HISTORIC AND DESIGN REVIEW COMMISSION

HDRC CASE NO: 2017-054
ADDRESS: 921 LAMAR ST
LEGAL DESCRIPTION: NCB 1369 BLK 6 LOT S 140 FT OF 14
ZONING: R-4 CD,H
CITY COUNCIL DIST.: 2
DISTRICT: Dignowity Hill Historic District
APPLICANT: Joseph Milligan
OWNER: Joseph Milligan
TYPE OF WORK: Rear addition, re-roof, skirting, door replacement
REQUEST:

1. Construct a rear covered porch with a gable roof
2. Re-roof existing standing seam metal roof with new standing seam metal roof
3. Install skirting
4. Replace door and transom light

Proposed

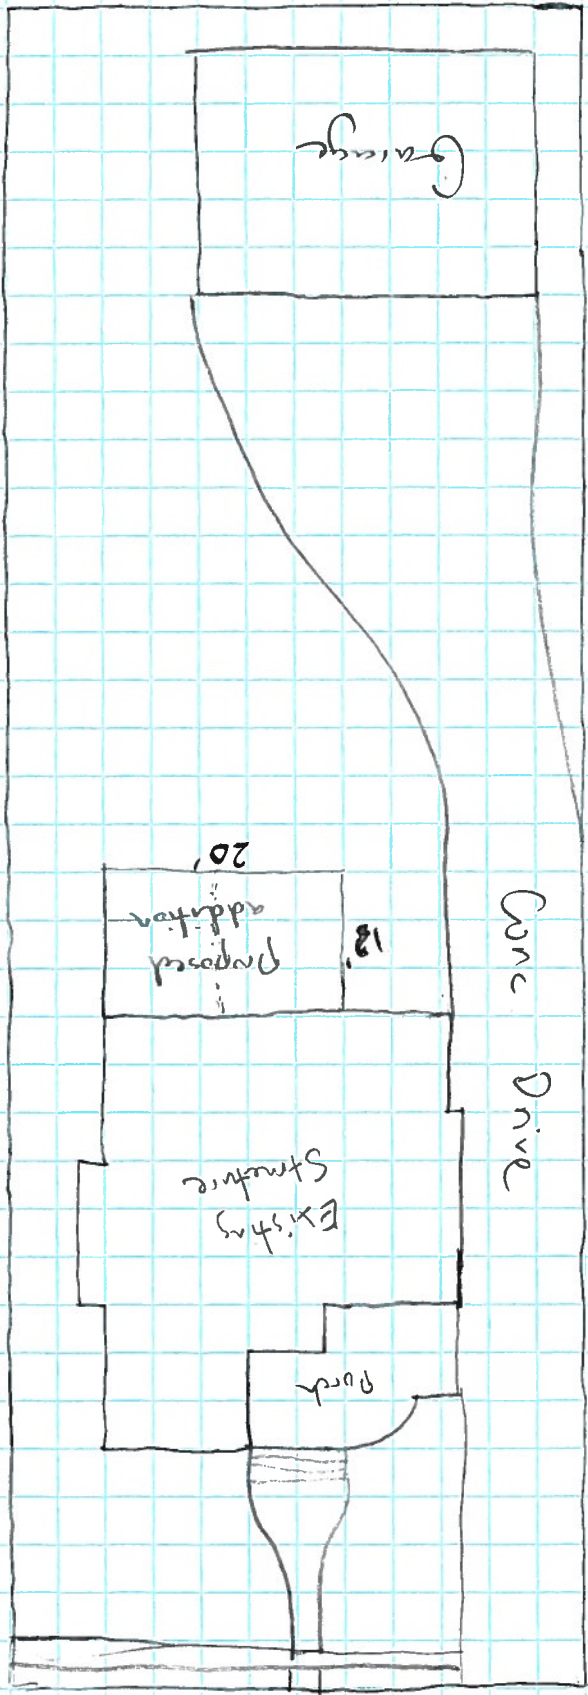
- c. ROOF FORM – The rear roof has a hipped roof form. The proposed addition has a rear gable that appears to meet the existing rear hip below the ridge height. According to the Guidelines for Additions 1.A.iii., use a similar roof form and orientation as the structure, particularly if visible from the street. Staff finds the proposed gable is not consistent with the existing rear roof form. Staff finds a hipped roof is more appropriate.

- d. TRANSITION – The proposed covered porch will have a rear gable roof, whose ridge starts below the ridge of the existing rear hip. According to the Guidelines for Additions 1.A.iv., there should be a small change at the seam in order to provide a visual distinction between old and new. Staff finds the proposed roof distinguished the addition from the main structure, thus is consistent with the Guidelines.

- e. SCALE & MASS – The proposed covered porch is approximately 240 square feet of covered, open space to the rear of the main structure. According to the Guidelines for Additions 2A. and .B.ii., new additions should be subordinate to the principle façade and not double the existing square footage. Staff finds the proposal consistent with the Guidelines in terms of scale and mass as it's lower in height and less than half the area of the main structure.

- g. ARCHITECTURAL DETAILS – The applicant is proposing a closed gable roof addition with a one over one window. The gable will be supported by 3 round columns. Staff has asked details about other modifications occurring along the rear façade, as it appears the windows in the elevation drawings are of different sizes, and the rear door location has changed. According to the Guidelines for Additions 4.A.ii., details should not overwhelm the original structure and be compatible with the style of the home. Staff finds the gable roof and gable window proportion consistent with folk Victorian homes, however recommends the applicant submit a more detailed existing and proposed site plan, that the windows not be modified, and that the window to be installed in the gable be made of wood, one over one to match the existing window material and configuration.

- 1. That the rear roof form be hipped
- 2. Skirting material consistent with the style of the home
- 3. If the rear gable is approved, the window to be installed in the gable should be made of wood, one over one to match the existing window material and configuration.
- 4. That the applicant submit the Historic Tax Certification application and required supplemental documentation

Standing Seam Galvalume Finish Roof

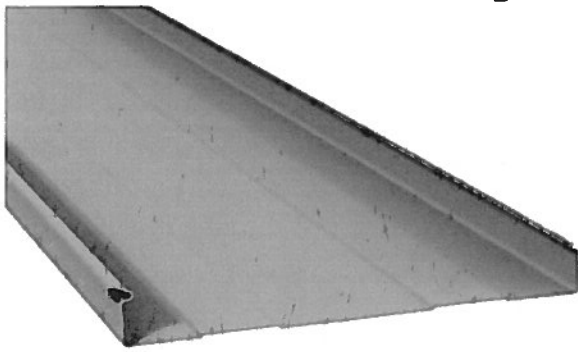
- b. RE-ROOF – The existing roof material is standing seam metal. The proposed new roof would match in-kind, matching the panel width, seam height, and installation method. Staff finds this is appropriate and consistent with the Guidelines.

- f. MATERIALS – The addition will have a standing seam metal roof to match the existing standing seam metal roof. The rear gable will have wood lap siding, columns and a porch decking. Staff has asked the applicant for details of the materials to be used, but has not received them at the time of posting. According to the Guidelines for Additions 3.A.i., materials that match in type, color and texture and include an offset to distinguish from the historic structure should be used. Staff is not able to make a determination at this time. Staff recommends that the columns and porch decking should be wood to be consistent with the Guidelines.
